Rockwell International

March 24, 1980

In reply refer to 80ESG-2661

Subject: Loose Parts Calibration

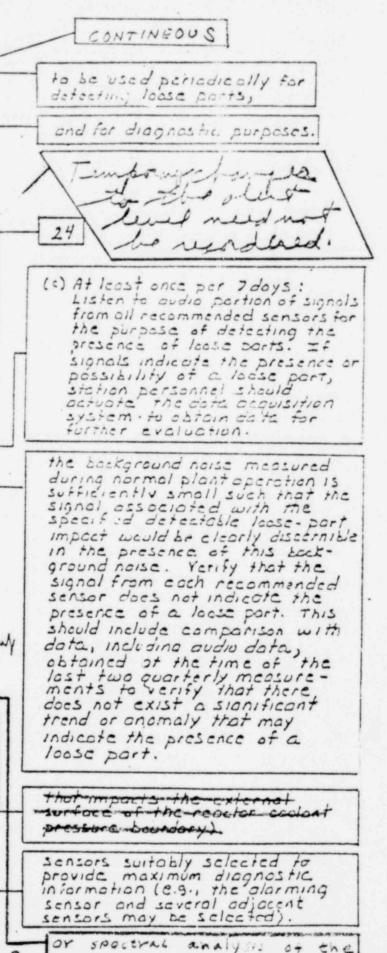
(c) (c) At least once per 92 days: Verify that dient levels are consistent with the cormal background noise and that the data do not indicate the prosense or possibility of a least part, anomalous behavior on a significant trend that may be safety related. The alert level and alert logic may be revised to provide for the background noise of these later measurements. The details of such a revision should be submitted within 60 days to the Commission as an amendment to the program description of the set once (3) Cold shutdown or refueling: At least once

(3) Cold shutdown or refueling: At least once per 18 months, verify channel calibration using a controlled mechanical inputies mought fulling through a known distance. Channels should, as necessary, be recalibrated at this time. If recalibration is necessary, consideration should be given to replacement of unstable components.
